ADDENDUM TO RFP DOCUMENTS

SOLANO COMMUNITY COLLEGE	ADDENDUM #02
	Project: Solano Community College District Vacaville Center HVAC Upgrade Project Project #18-010
	Date: February 28, 2018

Addendum # 02 – The following clarifications are provided based on questions received and must be added/considered when completing your submittal: Acknowledgement of receipt of this **ADDENDUM** is required in the proposal’s cover letter of introduction. Please clearly note the addendum date and number.

3 TYPICAL ROOF DRAIN
3" = 1'-0"

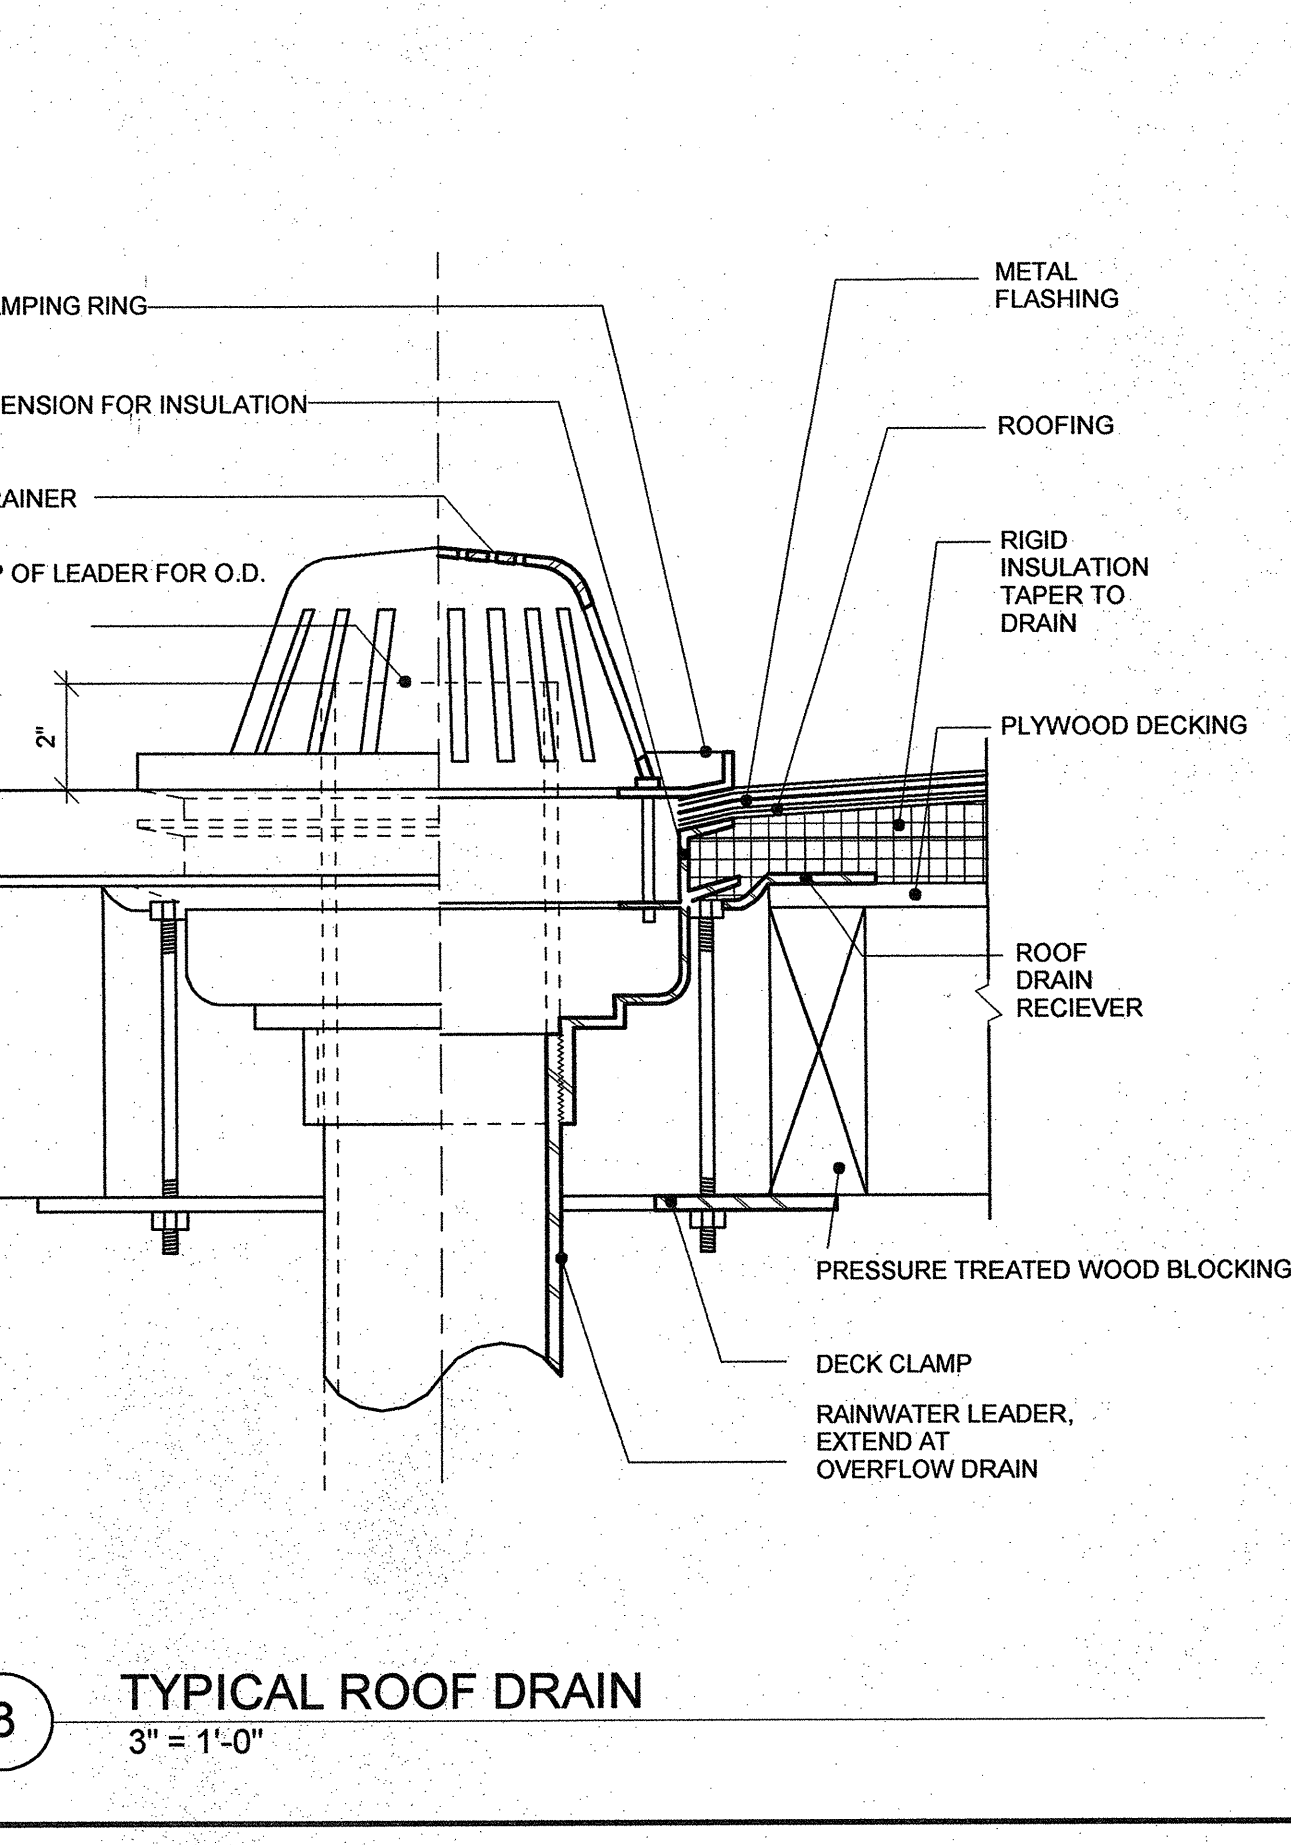
QUESTION –During the job walk it was determined that the existing roof system is fully tapered by rigid insulation ½” in 12” slope with a minimum of 6” at drains but not shown on the drawings. Please confirm and provide new details identifying existing insulation.

ANSWER – Please see the attached As-built drawings: A8.51, A8.52 & A8.53 for all the info of the existing roof condition (see attached).
